UNITED STATES PATENT AND TRADEMARK OFFICE

Office Action Summary

10/625,010

DETAILED ACTION

Fig. 1

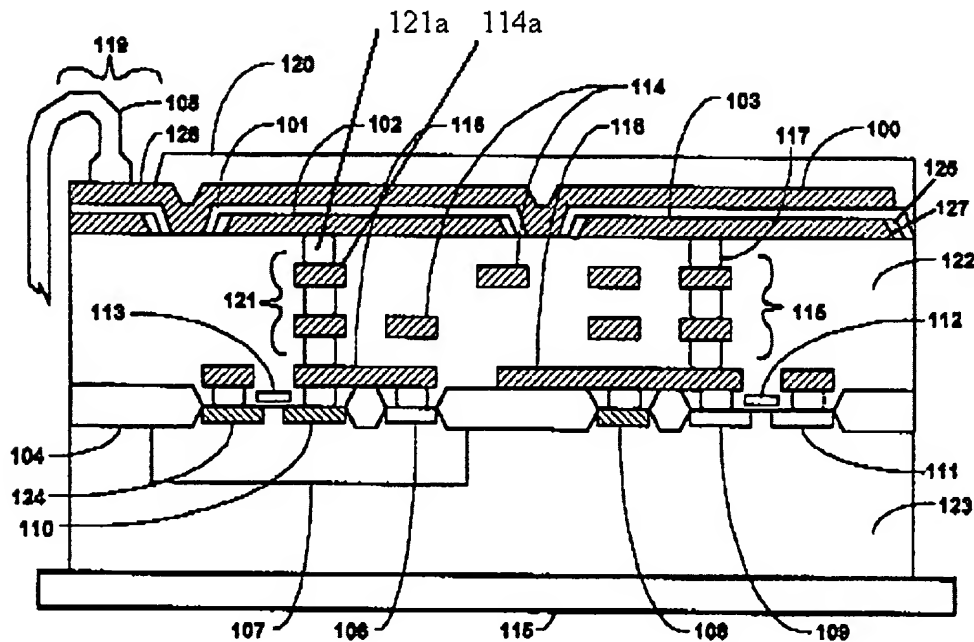
The '857 reference discloses in the figures, particularly Fig. 1, and respective portions of the specification a semiconductor device as claimed.

IC1. Referring to **claim 23**, the reference discloses a semiconductor device comprising:

a die (generally indicated at the structure comprising silicon substrate 123 and structure 122, Fig. 1) having:

a semiconductor structure (123) that includes a substrate (123) and a plurality of devices (one of which is a transistor comprising source/drain regions 124/110 and gate 113) that are formed in and on the substrate (This reference is introduced also to prove that in the pertinent art, a die having an integrated active circuit comprises a semiconductor structure that includes a substrate and a plurality of devices that are formed in and on the substrate); and

an interconnect structure (generally indicated at 122) connected to the semiconductor structure to electrically interconnect the devices to realize a circuit, the interconnect structure having a top surface, a dielectric structure (generally indicated at 122), a first metal region (114a, see below or next page) that contacts the dielectric structure, and a second metal region that contact the dielectric structure; and

a first conductive region (102, column 3, last full paragraph) having a first surface connected to an exterior surface of the interconnect structure and an opposing second surface;

an insulation region (101) having a first surface and an opposing second surface, the first surface of the insulation region contacting the second surface of the first conductive region; and

a second conductive region (a region of layer or region 100) having a first surface and an opposing second surface, the first surface of the second conductive region contacting the second surface of the insulation region, the second conductive region being electrically isolated from the first conductive region.

121a and 114a are added for ease of explanation

Referring to **claim 51**, the reference further discloses a first opening (generally indicated at 121a) formed in the dielectric structure, the first opening extending from the top surface down to the first metal region; and

a first conductive structure (121a) formed in the first opening, the first conductive structure being electrically connected to the first metal region (114a) and the first conductive region (102).
